Stones River Greenway Extension – Phase 4A

ADDENDUM NO. 1

October 20, 2014

1. Revised Pricing Worksheet (3 pages)
2. Revised Drawings (2 pages – C1.11, 4.01)

6 HEAVY DUTY ASPHALT
SCALE: NTS

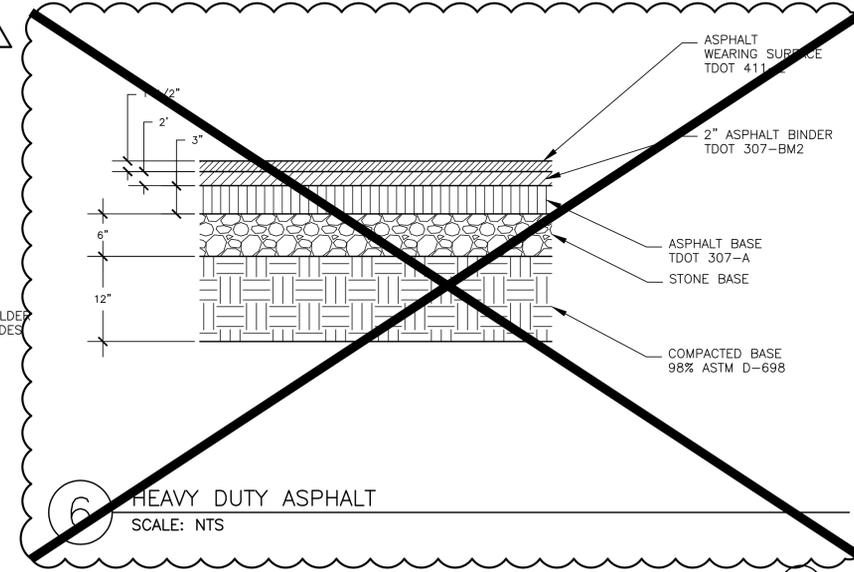
1. The Pricing Worksheet has been adjusted to include additional notes clarifying pricing protocol, a statement of Addenda receipt, and additional line items as identified below.
2. Heavy duty asphalt is not required for this project and all corresponding labels / details have been eliminated from the drawings.
